**ANYTHING BUT  
AVERAGE**

**STRICTLY  
TECHNICAL**

INDEX.PAGE.

## ASSEMBLY OF INLET MANIFOLD

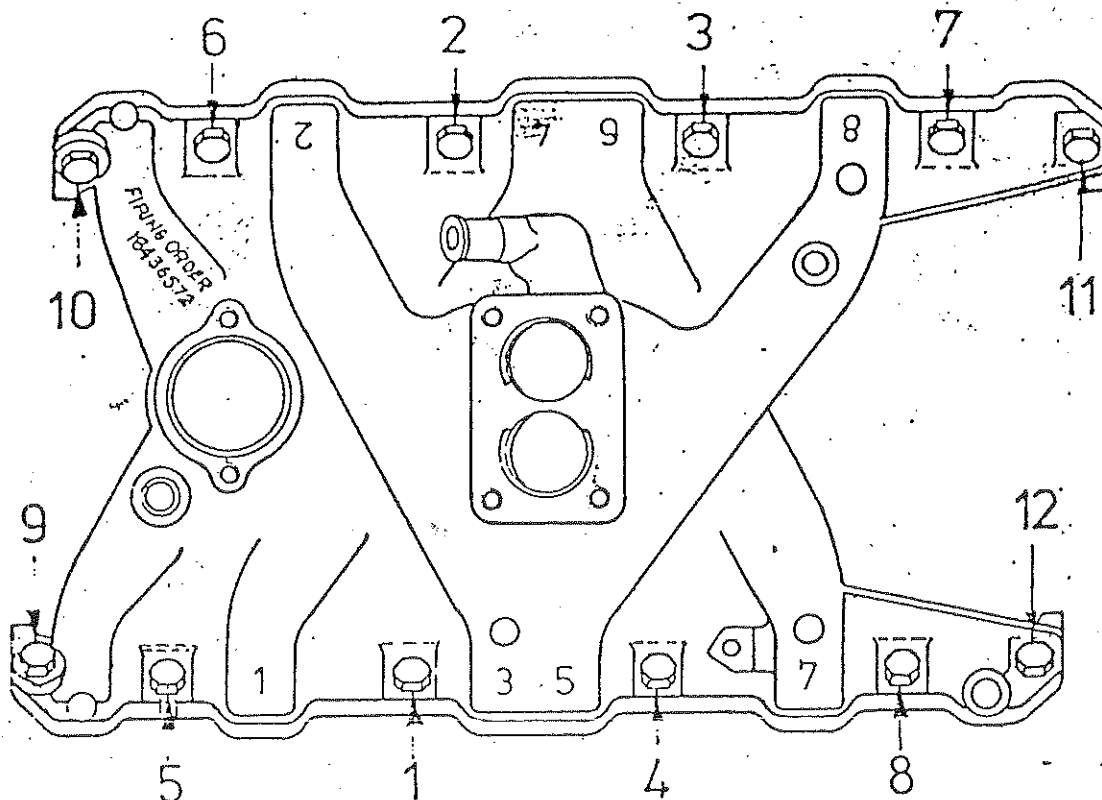
When investigating manifold gasket failure or poor idling on V8 engines it is imperative that the manifold retaining bolts be checked for length. There should be ten 1 1/2" x 3/8" and two 2" x 3/8" bolts at points 9 and 10 in Fig. 1. Instances of 1 3/4" bolts being used instead of 1 1/2" bolts have been reported. These can bottom on the threads and not fully clamp the gasket.

To minimise manifold distortion and maintain alignment between manifold and heads the following tightening procedure is required:

1. Fit valley cover gasket, align with ports then fit and tighten rubber end seals to pull valley cover gasket fully home.
2. Start all fixing screws by hand.
3. Run all screws down in sequence until contact with manifold casing is made, i.e. finger tight. If this is not done the first screw torqued will tilt the manifold in the valley and tightening the screw on the opposite bank does not correct the misalignment.
4. Tighten in sequence to 13.5 - 20 Nm (10-15 lbs. f. ft. Torque)
5. Tighten in sequence to 34 - 41 Nm (25-30 lbs. f. ft. Torque)

**NOTE:** If this is a repeat failure remove the left hand cylinder head and refit with a new gasket. Do not tighten the cylinder head until the manifold has been aligned correctly then tighten the head bolts to the correct torque.

ENGINE OIL CAPACITIES

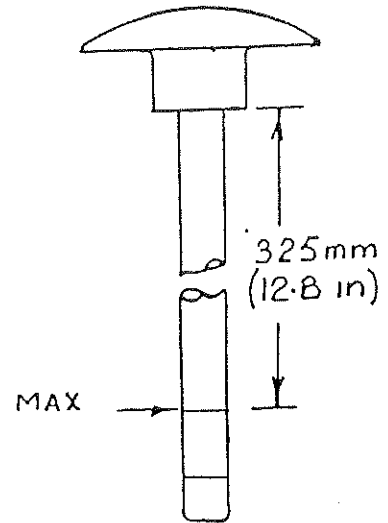
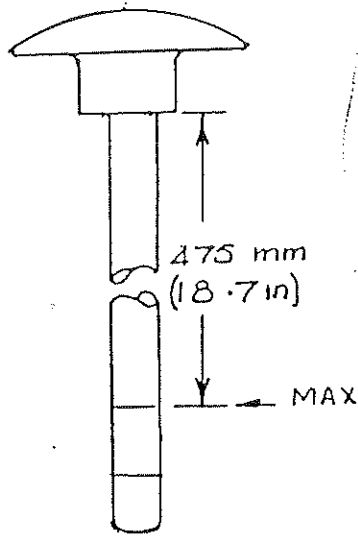
Field reports have been received indicating discrepancies in Engine oil capacities, refill quantities and dipstick graduations.

The following dipstick graduation dimensions and capacity figures are correct.

Dipsticks should not be remarked unless they vary from the dimensions shown.

Underside of knob to 'Max' mark.  
475 mm (18.7 in)

Underside of knob to 'Max' mark.  
325 mm (12.8 in)

#### OIL STARVATION

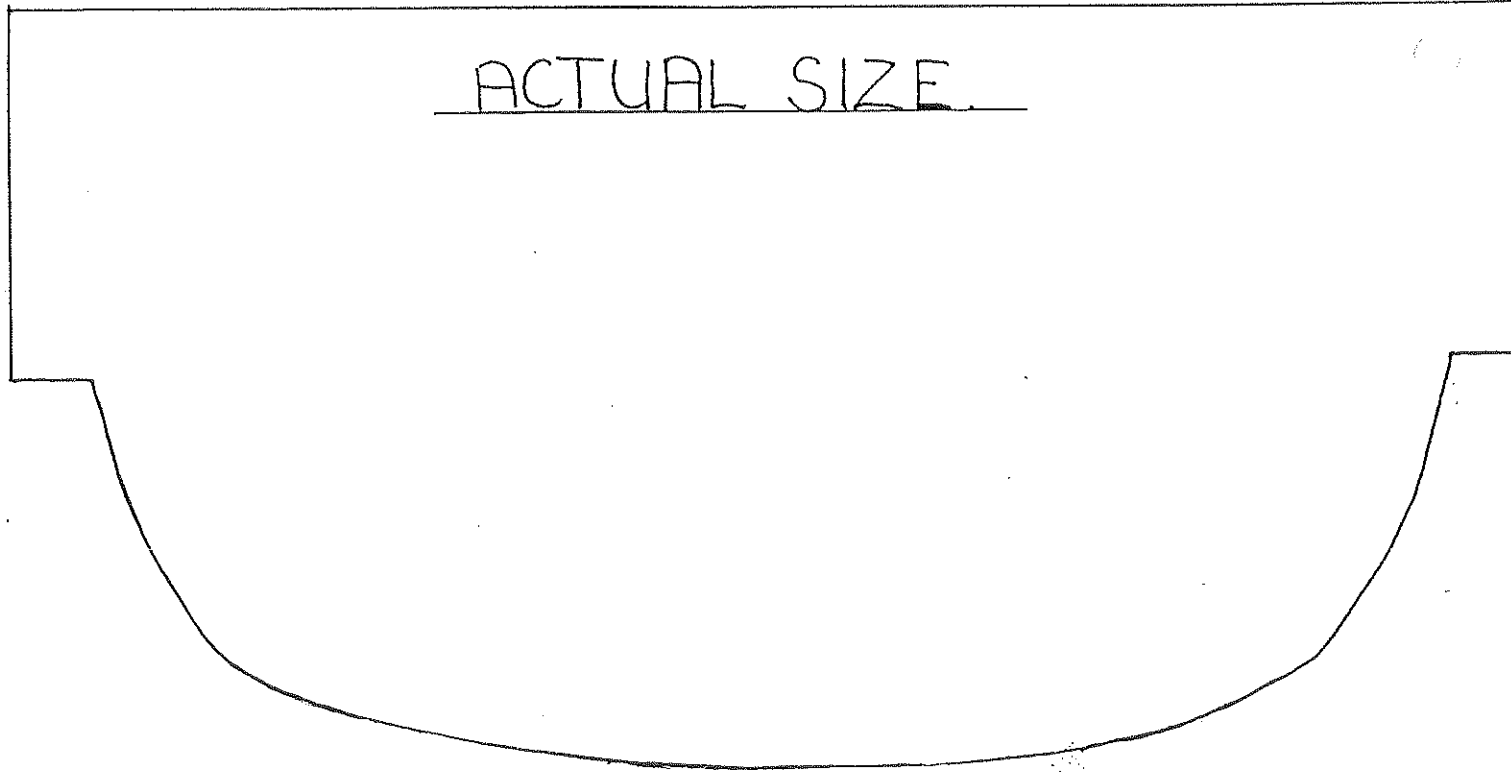
Oil starvation under heavy braking has been encountered in a small number of vehicles.

This problem can be rectified by manufacture and fitting of a reservoir baffle as shown in the attached drawing. In addition, vehicles having engines prior to the numbers listed below, should be fitted with oil pickup assembly Part No. AYD 0253.

ACTUAL SIZE

## THERMOSTAT - 6 CYLINDER P76 ENGINES

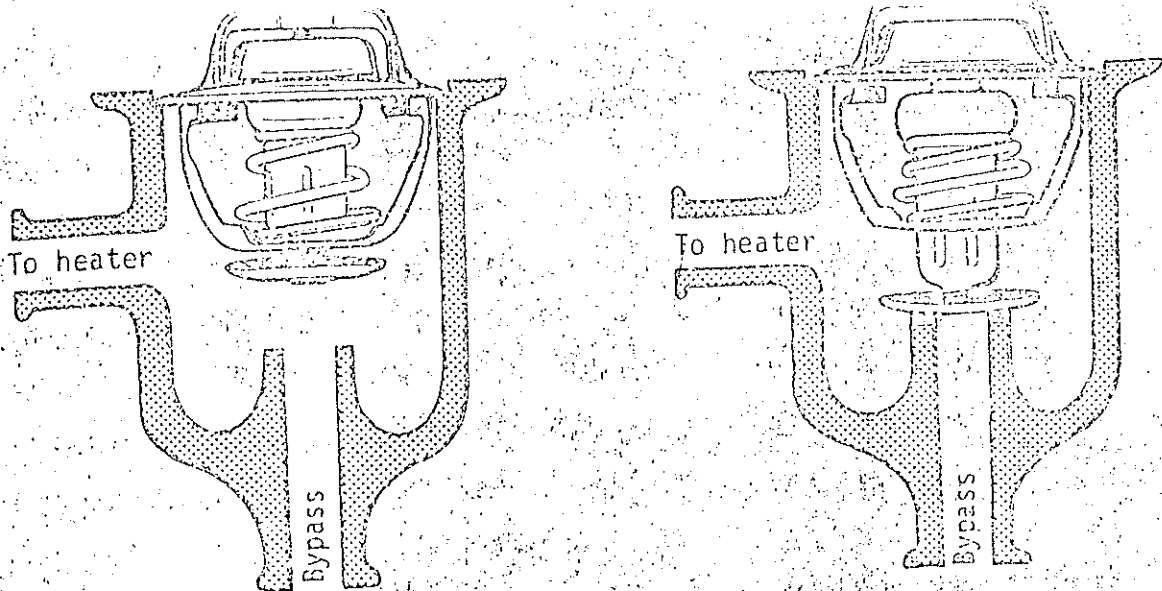
Investigations of overheating, loss of heater effectiveness and possible cylinder head gasket failure have been caused by a replacement thermostat of incorrect type being fitted. This allows the coolant to circulate through the bypass when the thermostat is open.

The correct thermostat has a spring loaded flap valve on the lower end of the wax cylinder. This valve closes the bypass when the thermostat is open ensuring correct circulation - see sketch.

Part No. 13H7508 is the only thermostat to be used on all 6 cylinder engines.

### OVERHEATING

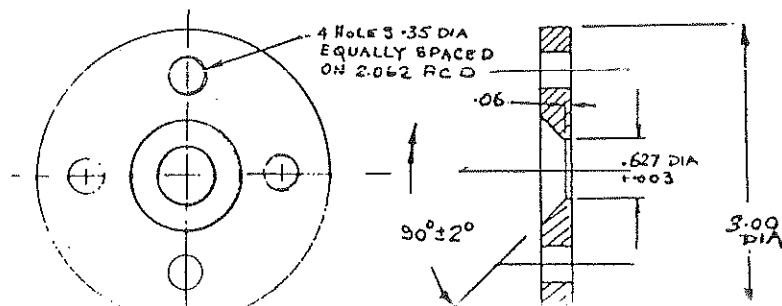
In the event of the V8 engine overheating during the summer months, an alternate cooling fan can be fitted to overcome the problem.

NOTE: It is essential that the new fan sit flat on the mounting face of the adaptor.

Where the machining of the adaptor is not practical, the fan mounting hole may be chamfered on the inside to clear the adaptor spigot radius, or alternatively a separate adaptor plate manufactured as shown in the attached drawing.

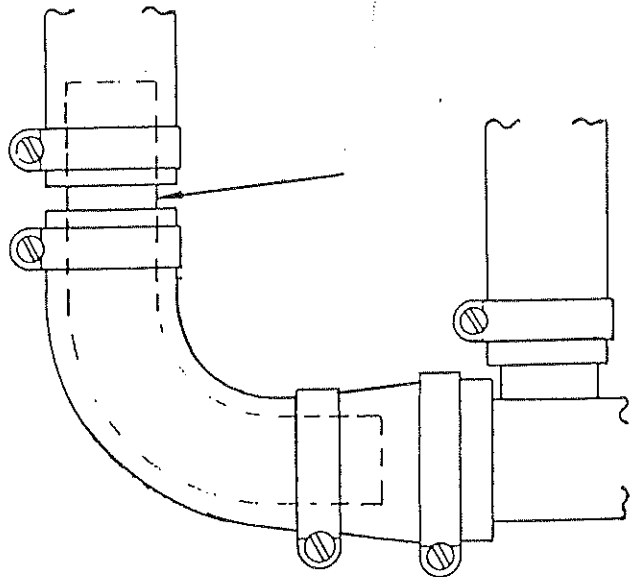
Instances of heater hoses failing adjacent to the water pump hose clip have been reported.

Should fatigue be evident, then a new hose should be fitted. In addition, further failures of this type can be prevented by the insertion of a 108 mm (4½ in) length of 12.7 mm (½ in) OD copper pipe in the hose and secured with hose clips as illustrated.

### FRONT SUSPENSION CROSSMEMBER MOUNTING

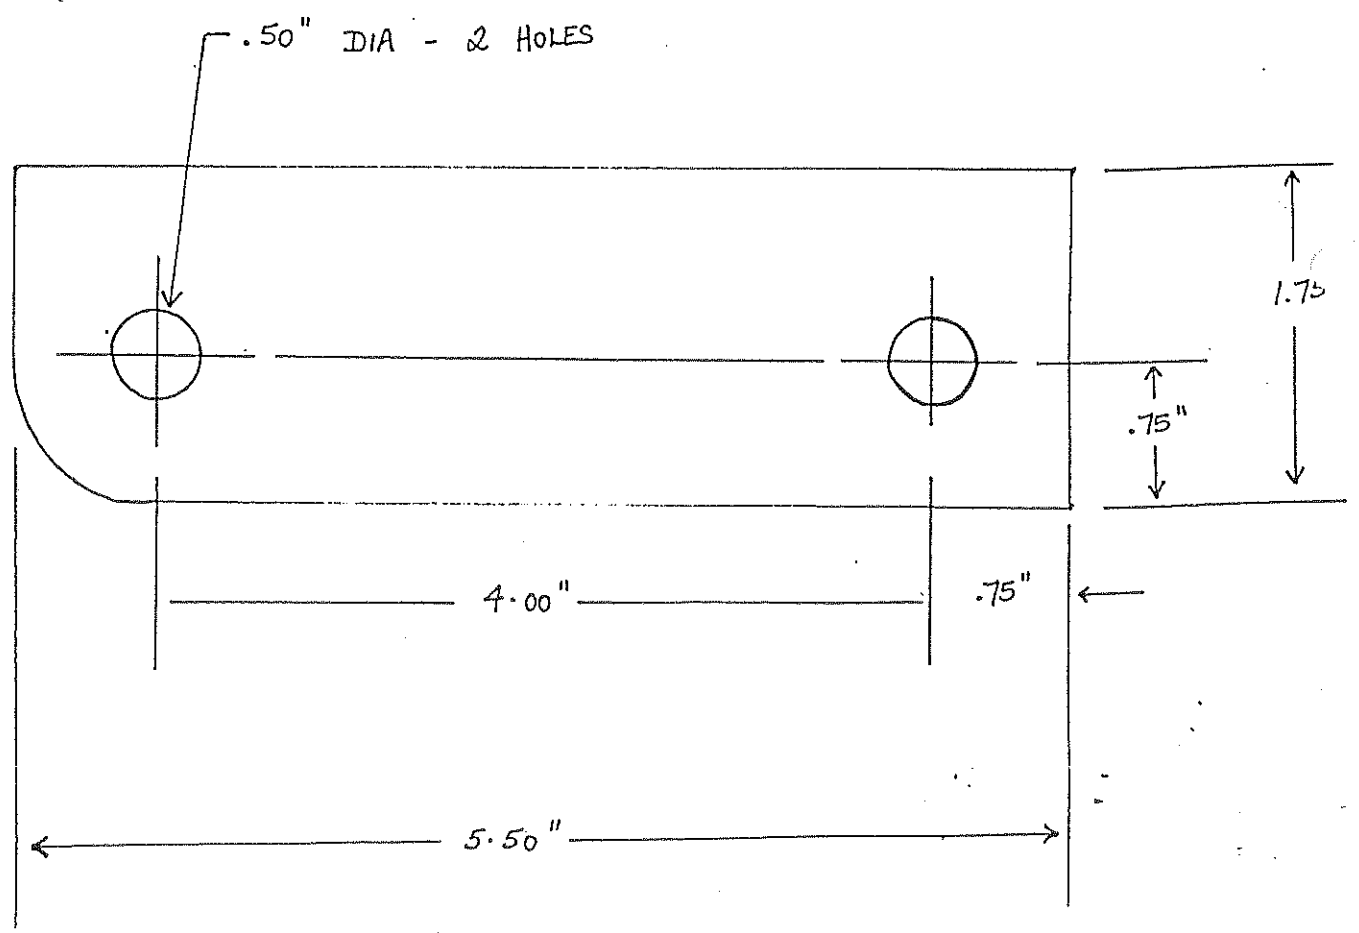
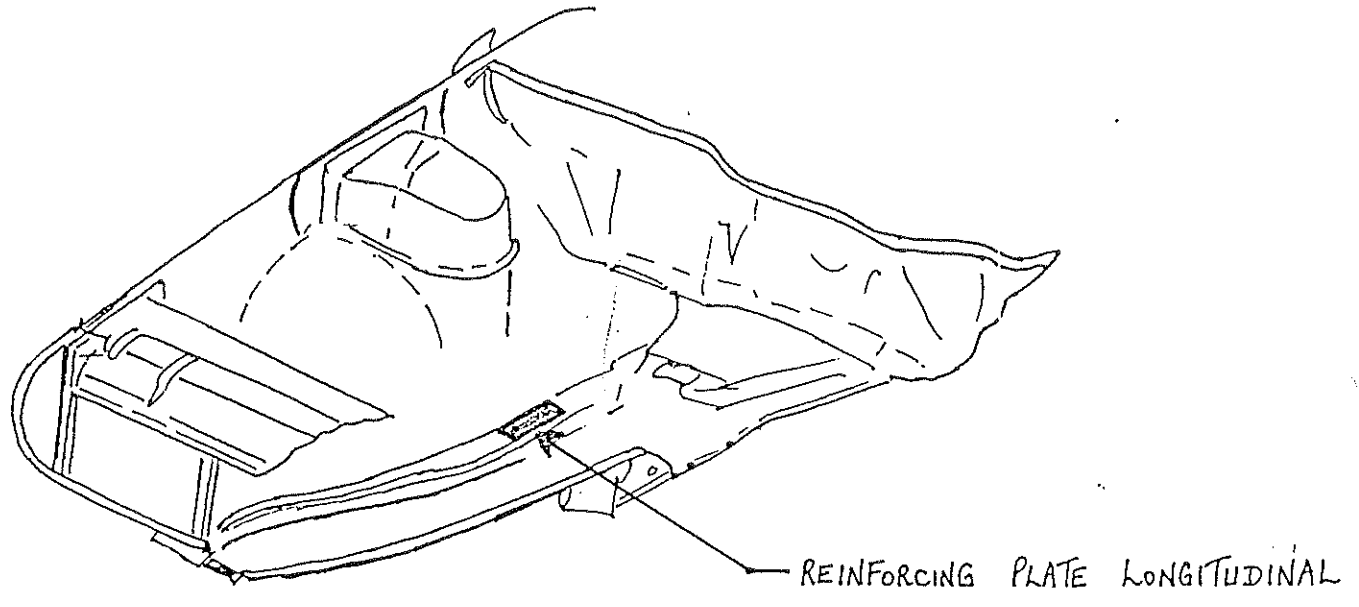
This bulletin announces the recent introduction of a reinforcement in the longitudinal member at the front suspension crossmember mounting bolt holes. This was introduced at body number:

Vehicles prior to the introduction of this modification may suffer from a rattle in this area due to movement of the crossmember. It is recommended that a 1/8" thick reinforcement plate is substituted for the flat washers used under the mounting bolt lock nuts.

To add the reinforcing plate remove the rear 7/16" UNF cone type locknut (MYH0790) and the plain washer (PWZ0107). Make sure that the bolt (HBZ0732) does not fall through. Place the reinforcing plate (HYC7834) with the rounded corner over the bolt and replace the locknut. Finger tighten the locknut. Do not replace the washer.

Undo the front locknut and remove the plain washer. Slide the reinforcing plate over the bolt and replace the locknut. Retighten the rear locknut.

## TIE BAR RUBBERS

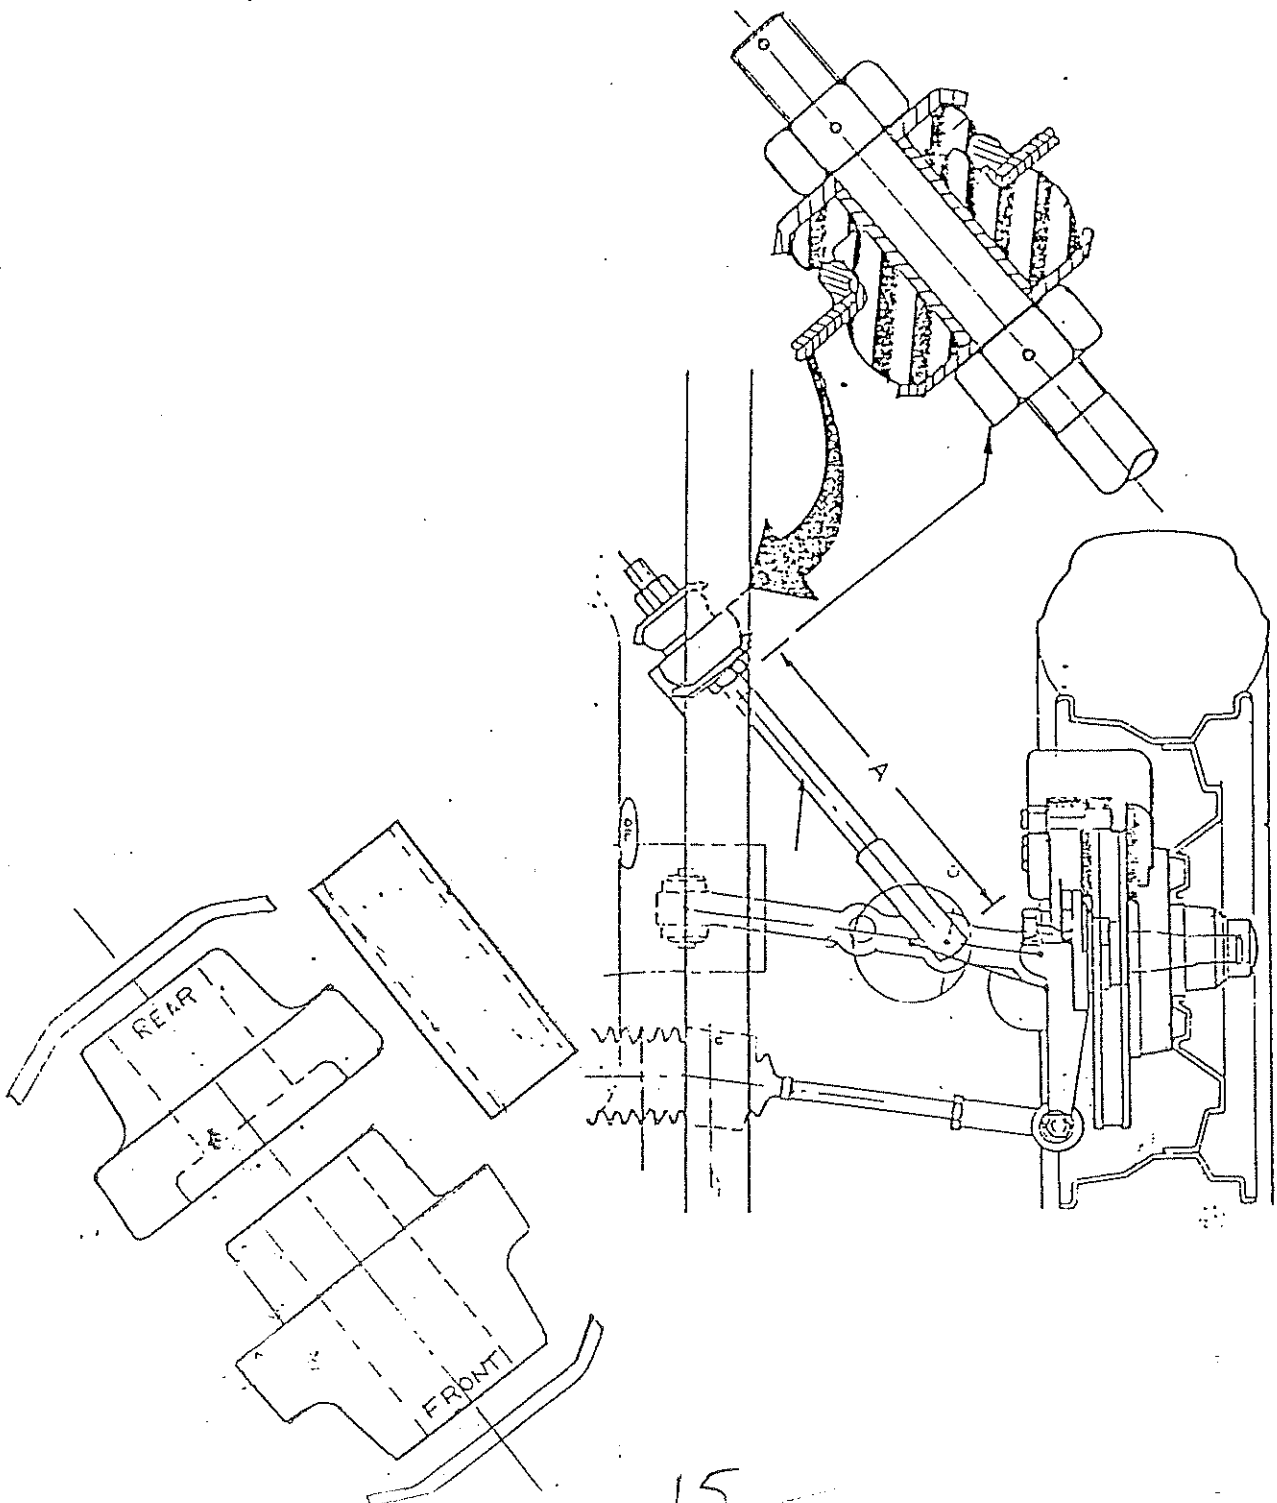
Where vehicles are operating continuously under adverse conditions, the tie bar rubbers may not achieve their anticipated life expectancy.

In this event, a heavy duty replacement package is available under Part No. HYL 5080.

These rubbers require an additional 6.3 mm (0.25 in) sleeve to be fitted to the rear bush on assembly. This sleeve can be cut from a standard MYH 1131 sleeve.

Assemble the components as shown in the sketch.

NOTE: The effective length of the tie bar is reduced to 276.2 mm (10-7/8 in) when using this package, and the twin-lock-nut torque remains unchanged at 68-95 Nm (50-70 lb.f.ft).

## INTERMITTENT STARTER SOLENOID OPERATION

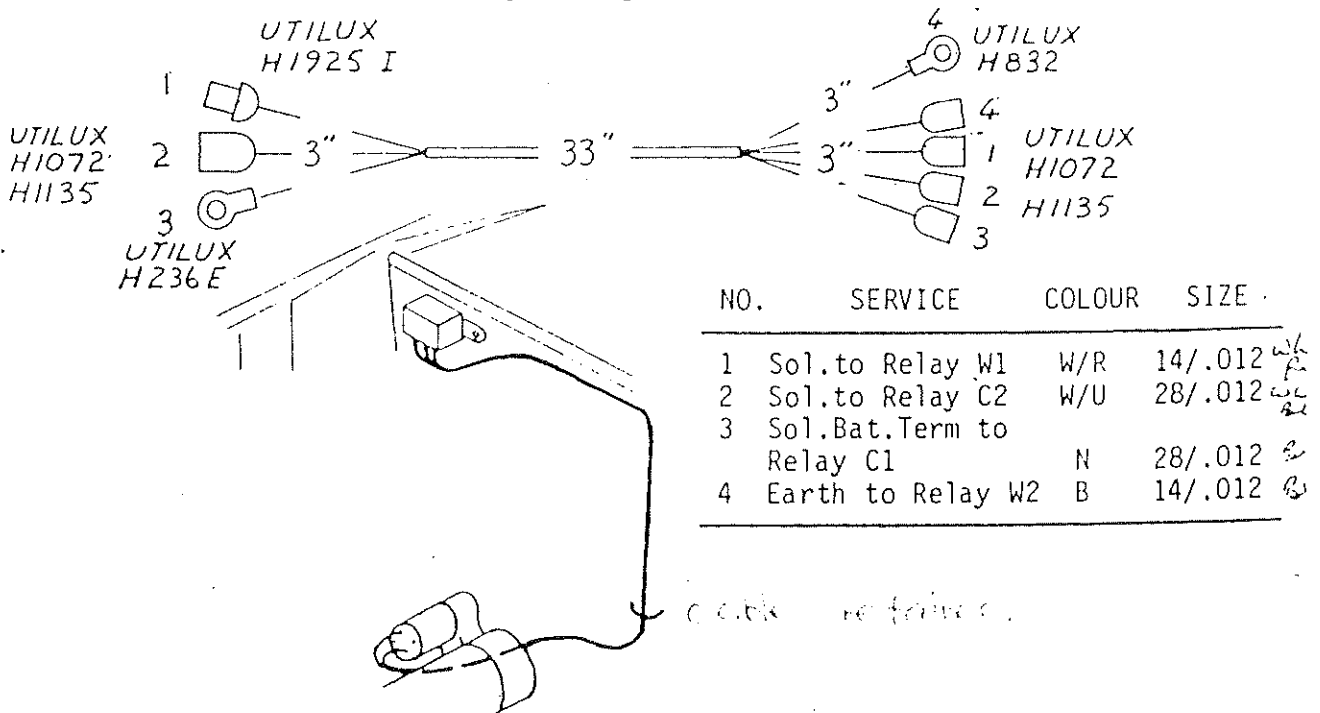
Should test indicate considerable voltage drop in the ignition switch to solenoid circuit, the following method offers an alternative solution.

1. Fit Lucas relay Part No. 33213 to the plenum chamber wall on the RH side.
2. Manufacture wiring harness as shown in drawing.
3. Route cable over brake servo and follow main harness to starter solenoid.
4. Remove white/red cable from the starter solenoid and connect to male terminal on harness.
5. Connect white/blue cable to starter solenoid terminal.
6. Connect brown cable to battery terminal on starter solenoid.
7. Connect harness to relay as shown.
8. Fit earth cable under relay fixing screw.
